UNITED STATES PATENT AND TRADEMARK OFFICE

APPLICATION NO.	FILING DATE	FIRST NAMED INVENTOR	ATTORNEY DOCKET NO.	CONFIRMATION NO.
10/829,656	04/22/2004	Nick Boulachanis		6836

Office Action Summary

DETAILED ACTION

Figure 2), and said object includes a support (as seen in the partial illustration of Figure 2 below);

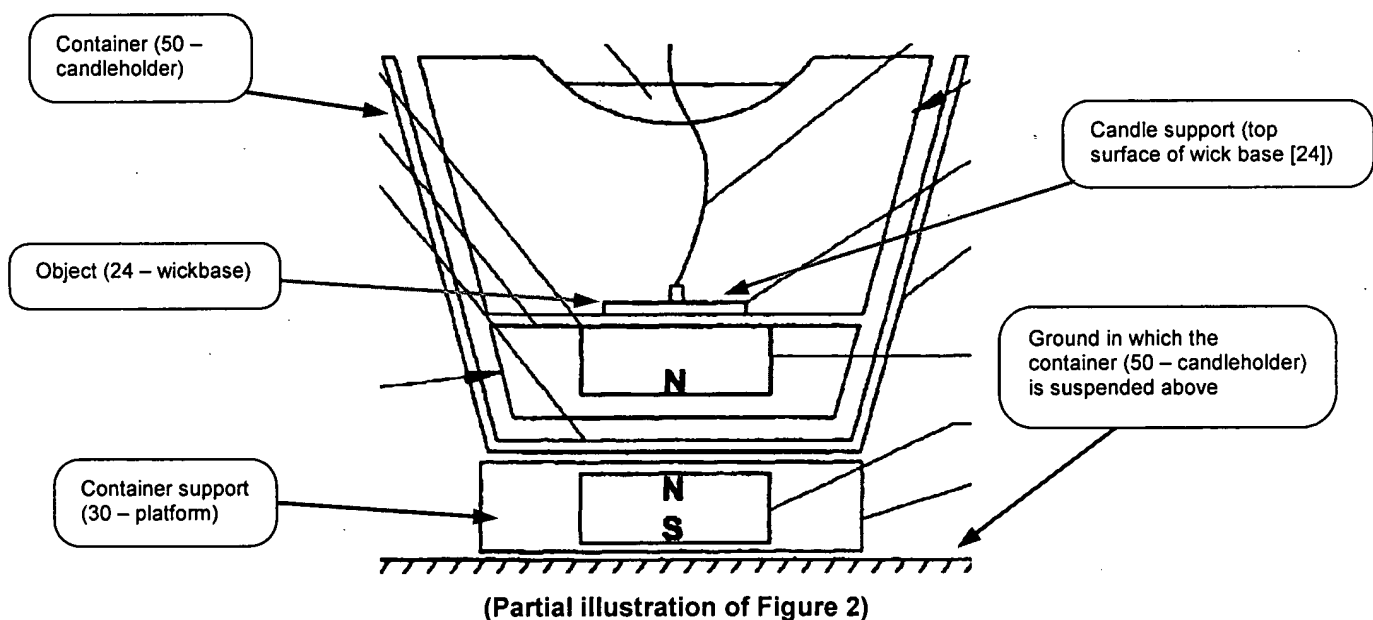
- a container (50 – candleholder) for receiving a liquid (26 – melted wax; col. 4, lines 53-66);
- an object (24 – wickbase), said object being substantially buoyant (by further of the fact that the candle floats on the wax, the candle must be buoyant) and supportable by the liquid while being at least in part submerged into the liquid (as seen in Figures 3, 4, 6);
- a first magnet (340 – second magnet) mounted to said object (as seen in Figure 9), said first magnet defining first magnet first and second magnetic poles having opposed polarities (as seen in Figure 9);
- a lit candle (20 – candle; Figure 2) selected from the group consisting of wax candles (see col. 4, lines 63-66), placed on the surface of said object (as seen in

- a second magnet (35 – first magnet) movable over a predetermined path relatively to said container (see col. 3, line 66 – col. 4, line 7), said second magnet defining second magnet first and second magnetic poles having opposed polarities (as seen in Figure 9);
- a container support (30 – platform) for suspending said container (as seen in Figure 2, the platform [30] suspends [or holds] the candleholder above the ground).

Fig. 8

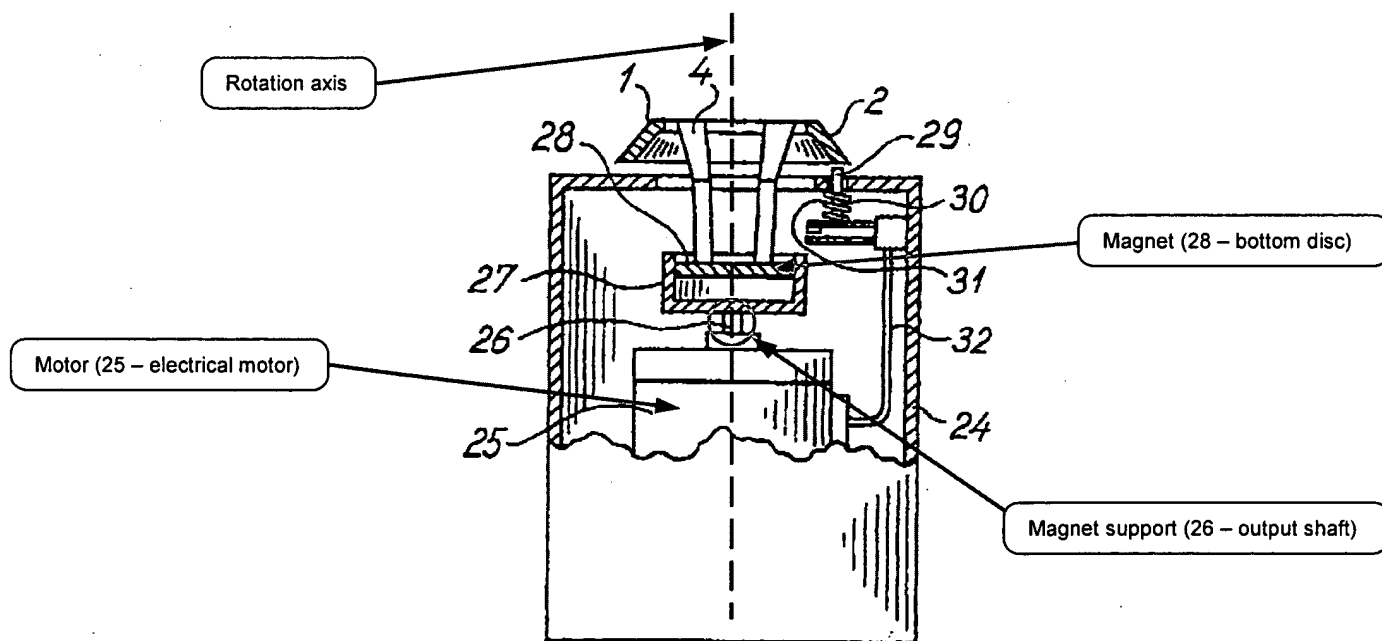
- a magnet (28 – bottom disc; col. 6, lines 4-8; Figure 8);
- a motor (25 – electrical motor; Figure 8) and a magnet support (26 – output shaft; Figure 8), said magnet being mounted to said magnet support (as seen in Figure 8) so that at least one of the magnet first and second magnetic poles is located eccentrically relative to said rotation axis (as seen in the illustration of Figure 8 below)
- a motor casing (24 – housing), said motor, magnet support and magnet being mounted into said motor casing (as seen in Figure 8).

It would have been obvious to one of ordinary skill in the art at the time of the invention to modify the existing apparatus of Gaudioso in view of Cafolla by incorporating a motor, magnet and magnet support that rotate in a circular pattern, as taught by Jensen, so
